GTS 711 HVAC Repairs Project

PROJECT NO. 31090728

A D D E N D U M N O . 1

SHEET NAME:
MECHANICAL PLAN - AREA A

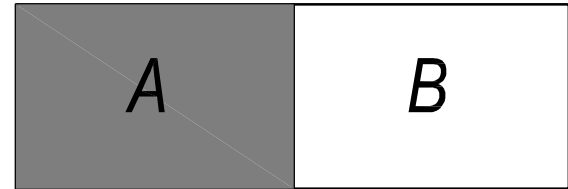
ADD 1-6: Sheet M1.1A – Mechanical Plan – Area A
a. Revised condensate serving F-1 to utilize condensate pump that will discharge to service sink in Mech/Storage room.

1. EXTEND NEW 1" HDPE GAS PIPING TO ABOVE GRADE AND TRANSITION TO STEEL PIPING BEFORE EXTENDING INTO BUILDING.
2. PROVIDE ISOLATION VALVE, DIRT LEG, 2 PSI TO LOW PRESSURE REGULATOR, AND FLEXIBLE CONNECTION FOR FURNACE.
3. UNDER ABI #1 EXTEND 3/4" CONDENSATE FROM EVAPORATOR AND FURNACE. EXTEND PIPING ALONG WALL TO DRAIN INTO EXISTING SERVICE SINK. COORDINATE ROUTING AND SLOPE.
4. EXTEND 3/4" CONDENSATE FROM EVAPORATOR AND FURNACE. CONNECT PIPING TO CONDENSATE PUMP (P-1) AND EXTEND TO SERVICE SINK IN STORAGE ROOM 107.
5. UNDER ABI #1 EXTEND 3/4" CONDENSATE FROM EVAPORATOR AND FURNACE TO ABOVE EXISTING FLOOR DRAIN.

M3.0

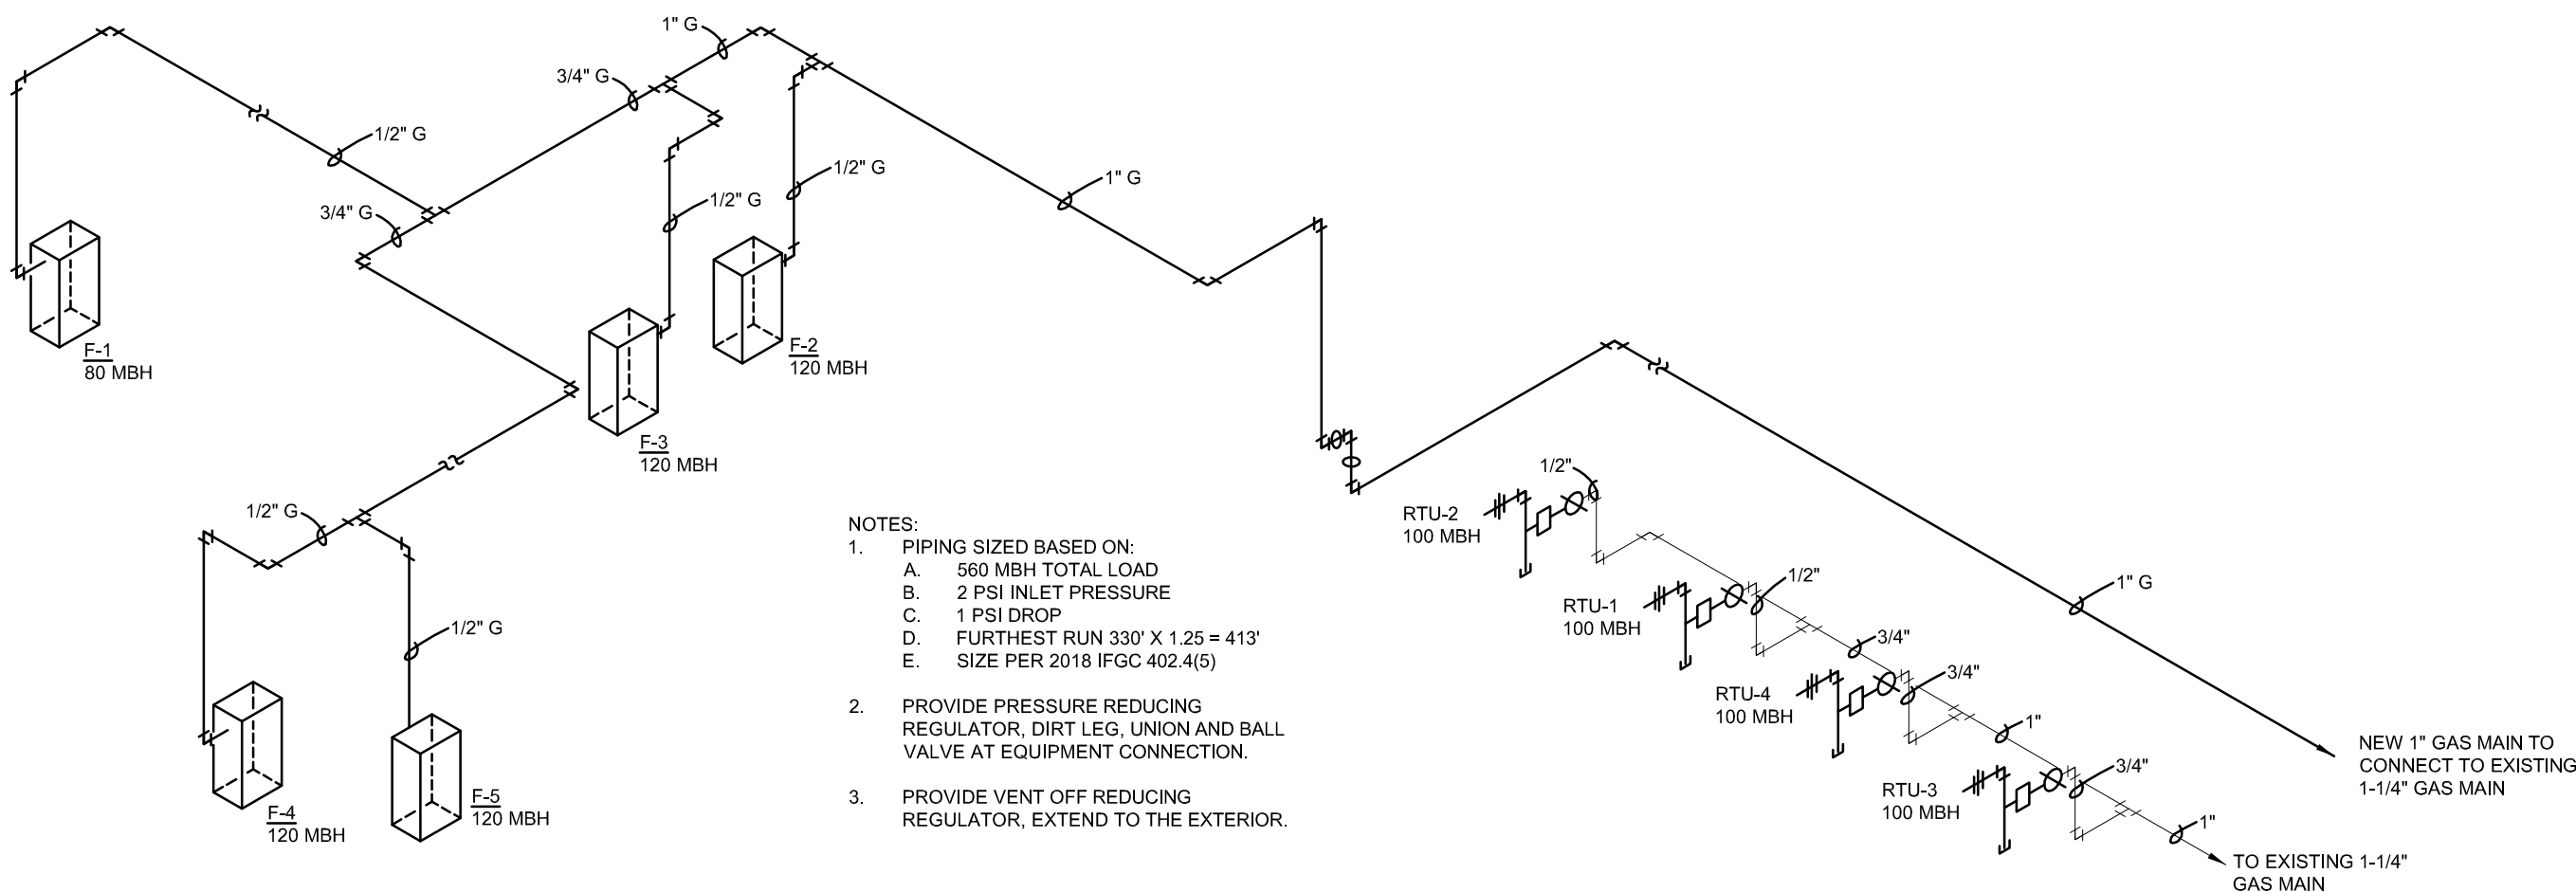
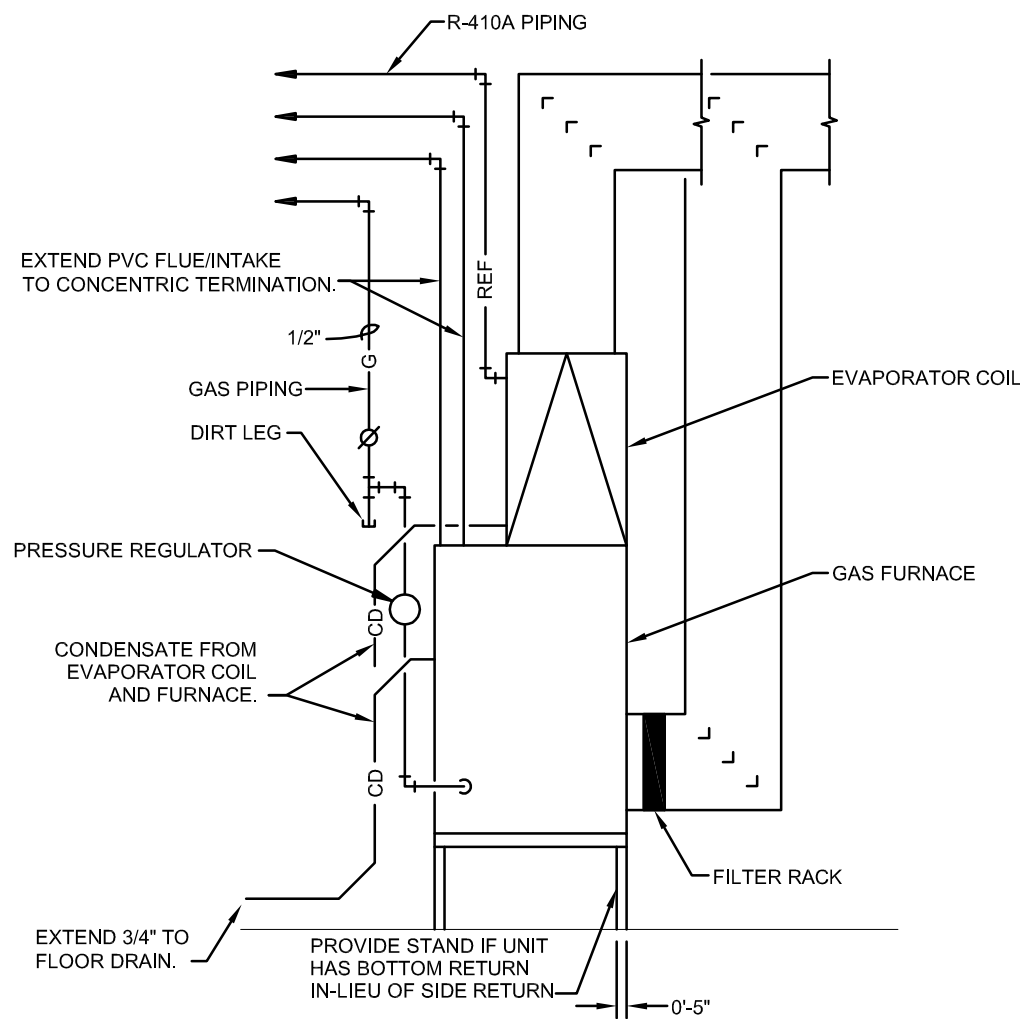
ADD 1-7: Sheet M3.0 – Mechanical Details and Schedules
a. Revised Mini-split schedules
b. Added condensate pump schedule

- NOTES:**
1. COOLING CAPACITY BASED ON 100°F AMBIENT AIR AND 80°F D.B./67°F W.B. RETURN AIR.
 2. HEATING CAPACITY BASED ON 70°F DB E.A.T. AND 5°F DB O.A.T.
 3. PROVIDE CONDENSATE PUMP TO LIFT CONDENSATE TO ALLOW FOR GRAVITY DRAINING.
 4. UNIT TO PROVIDE HEATING TO -4°F COOLING TO 10°F.
 5. PROVIDE HARDWIRED THERMOSTAT FOR UNIT CONTROL. COORDINATE CONNECTION TO BMS TO MONITOR/CONTROL UNIT.
